UNITED STATES PATENT AND TRADEMARK OFFICE

APPLICATION NO.	FILING DATE	FIRST NAMED INVENTOR	ATTORNEY DOCKET NO.	CONFIRMATION NO.
10/760,531	01/21/2004	Hiroaki Mochizuki	118255	1091

Office Action Summary

DETAILED ACTION

Fig. 5

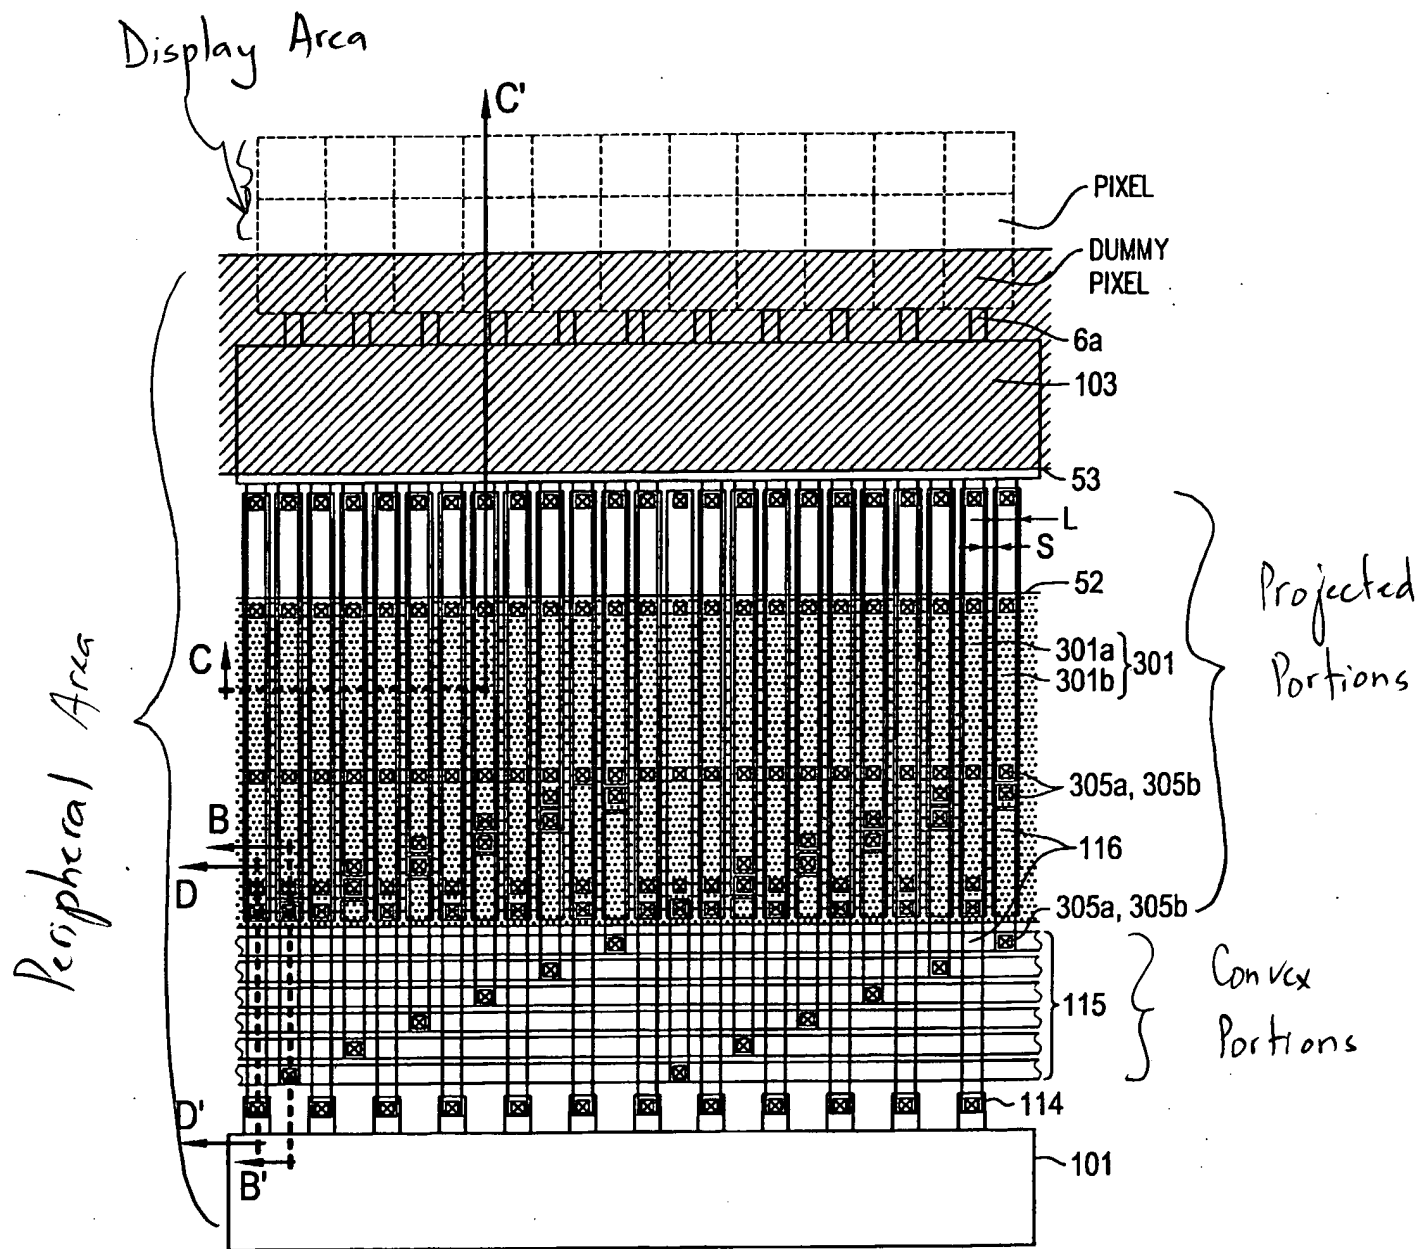
the substrate 10 having an image display area (pixels on top of Fig. 5) defined as an area to form the pixel electrodes 9a and the switching elements 30 (Fig. 1), and a peripheral area defining the periphery of the image display area where a shielding film 53 is a part of the peripheral area (see also Fig. 15), the alignment film 16 being formed in the image display area, and convex portions (on top of image data lines 115 in Figs. 5 and 6) in being formed in at least a part of the peripheral area.

Re claim 3, as shown in Fig. 5, the electro-optical device of Murade further includes a dummy pixel forming area formed outside the image display area, the convex portions being formed outside the dummy pixel forming area.

Re claim 8, as shown in Fig. 5 of Murade, the pitch between the linear convex portions is equal to the pitch between the projected portions.

Fig. 6

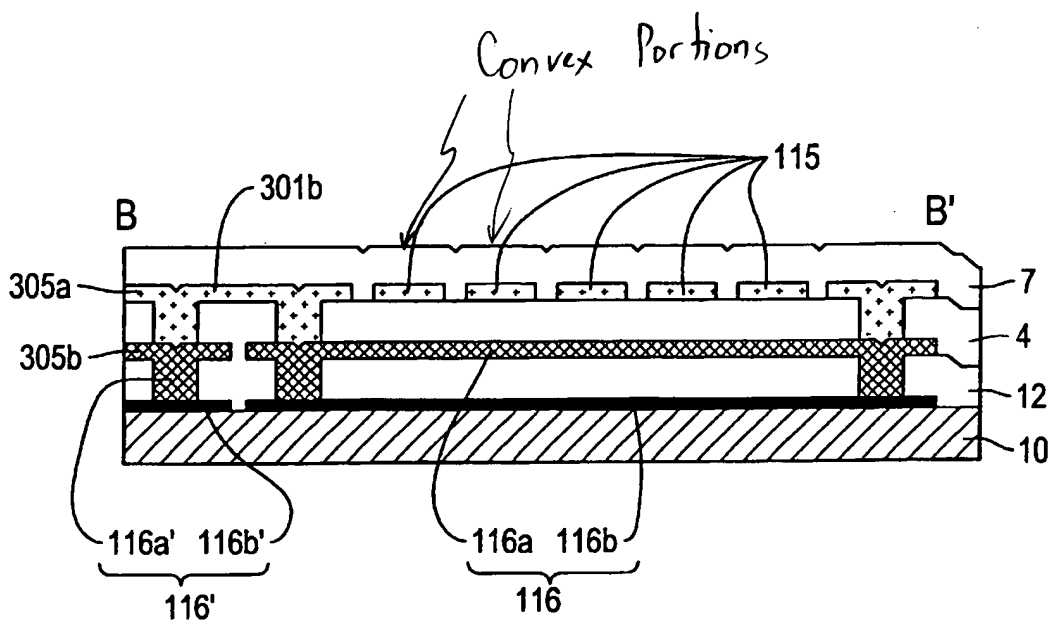
Re claim 4, as shown in Figs. 5 and 6, Murade discloses that projected portions on top of wirings 301 caused by the extended data lines 301 are formed in an insulating layer 7 (col. 18, lines 44-49), and

the height of the convex portions is equal to the height of the projected portions as shown in Figs. 6 and 7.

Fig. 7

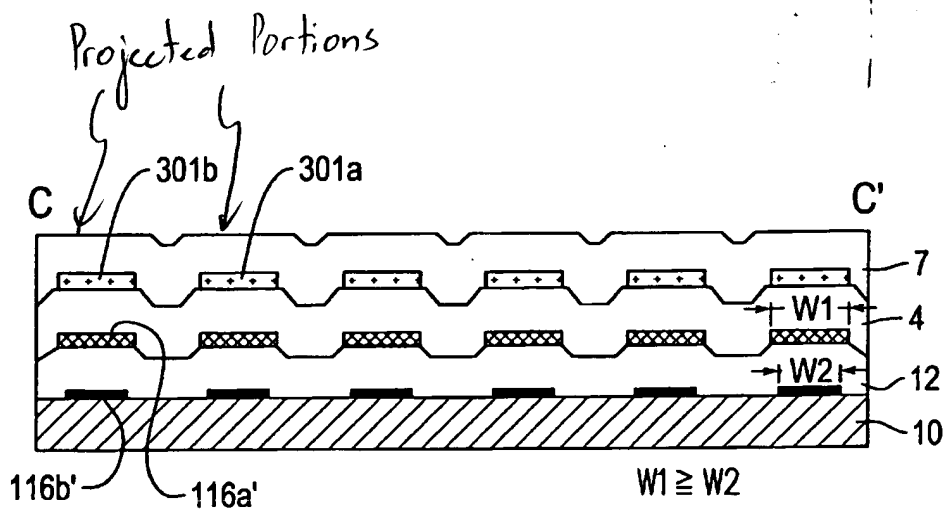
Re claim 5, as shown in Figs. 5 and 7, Murade discloses that projected portions caused by the height of the data lines 301 are formed in an insulating layer 7, and
